Agenda
Planning Commission Meeting
Wednesday, August 28, 2024
Richland City Hall ~ Council Chambers
625 Swift Boulevard

2. CA2021-108 Badger Mountain South Land Use Development Regulations (LUDR) Amendments
- Mike Stevens, Planning Manager

PLANNING COMMISSION AGENDA ITEM COVERSHEET

TO: PLANNING COMMISSION
FILE NO.: CA2021-108

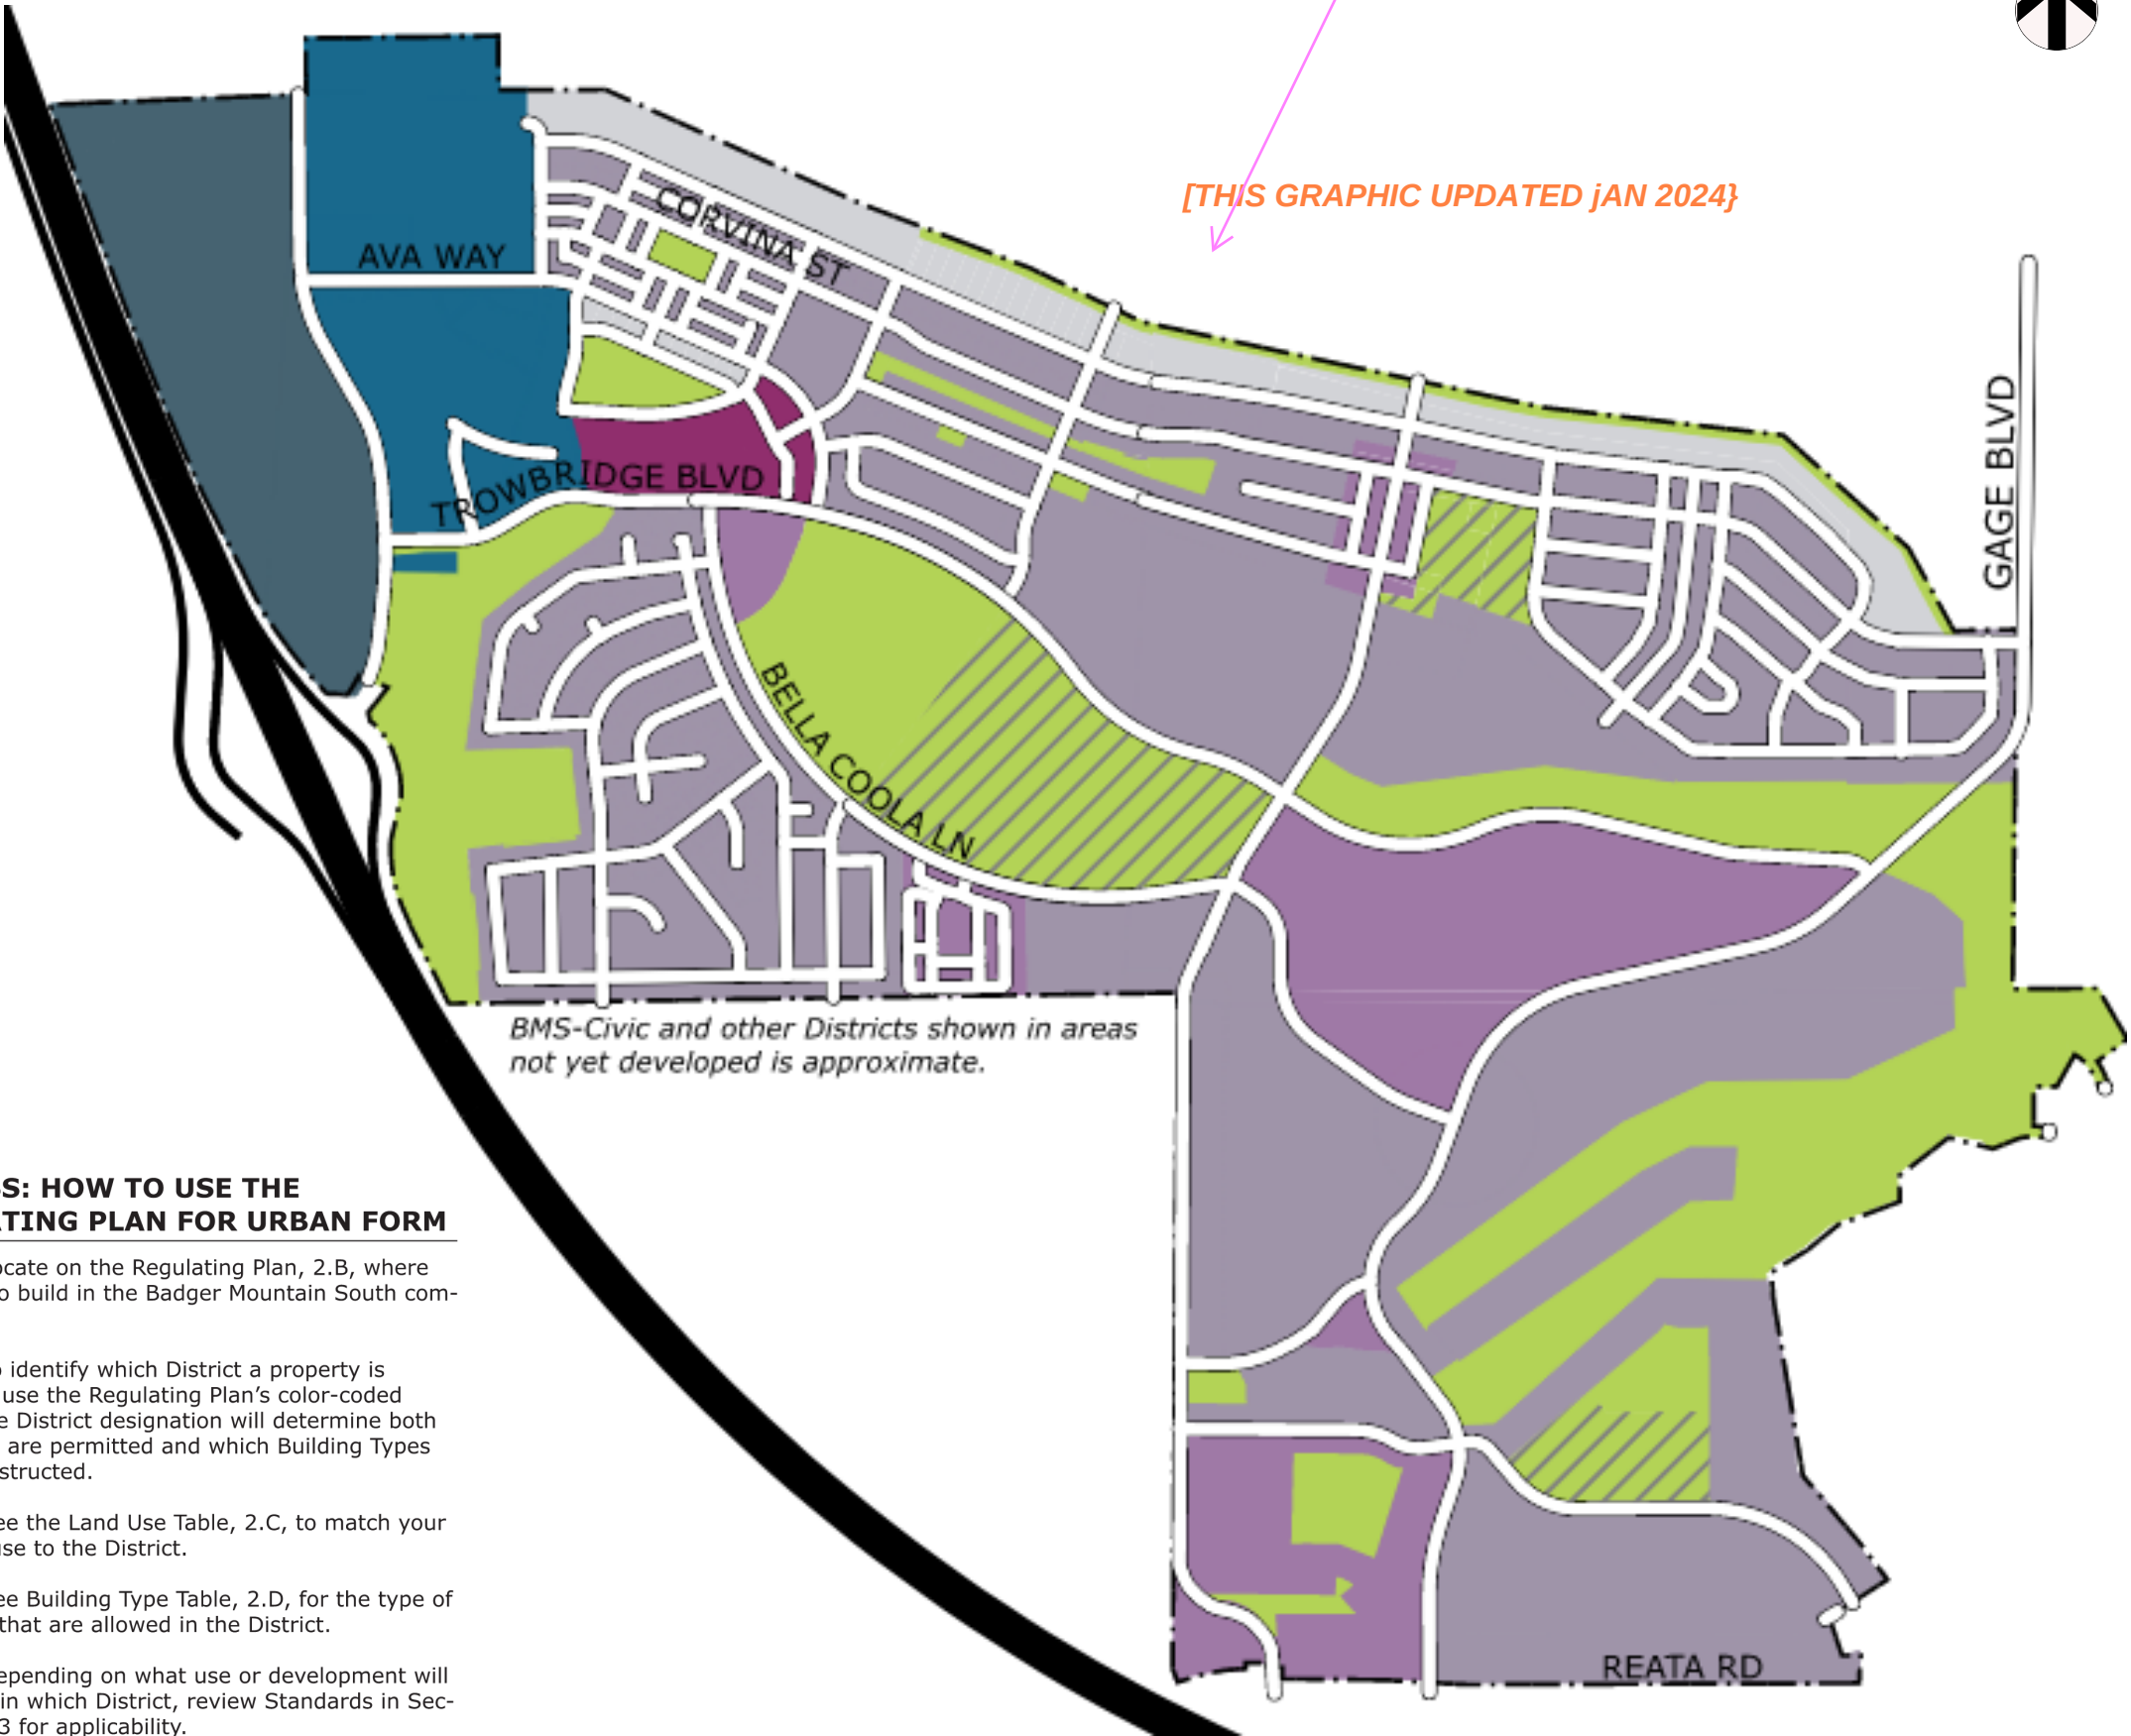
~~SPECIAL DESIGNATION “-P” OVERLAY DISTRICT~~

Building Placement Diagram (Plan View)

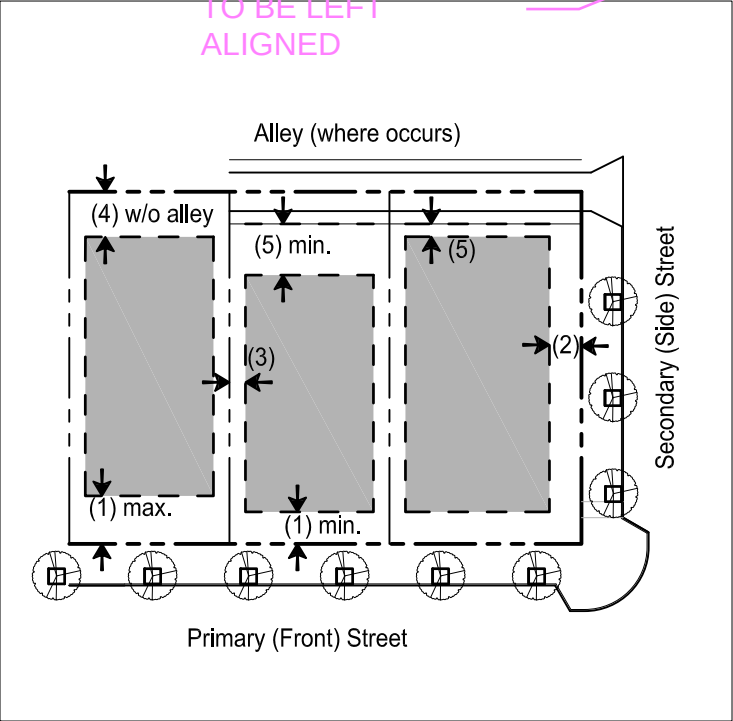
CHANGE POSITION
TO BE LEFT
ALIGNED

6B.2B MINOR COLLECTOR / LOCAL STREET (TYPICAL)

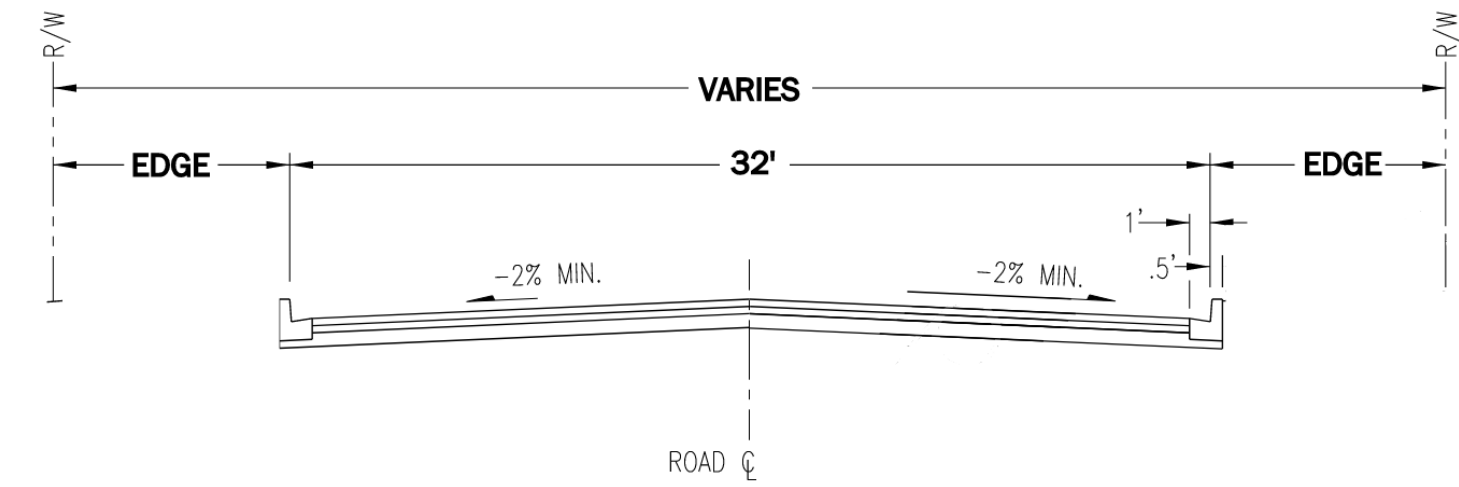
Do we need a note saying that parking on both sides is OK, and will not be restricted?

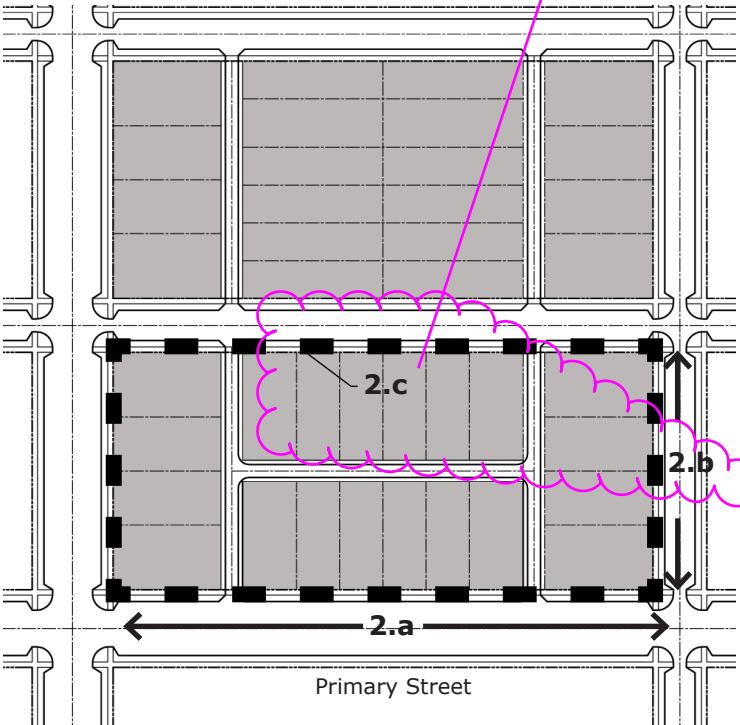
Remove 2.b and 2.c labels
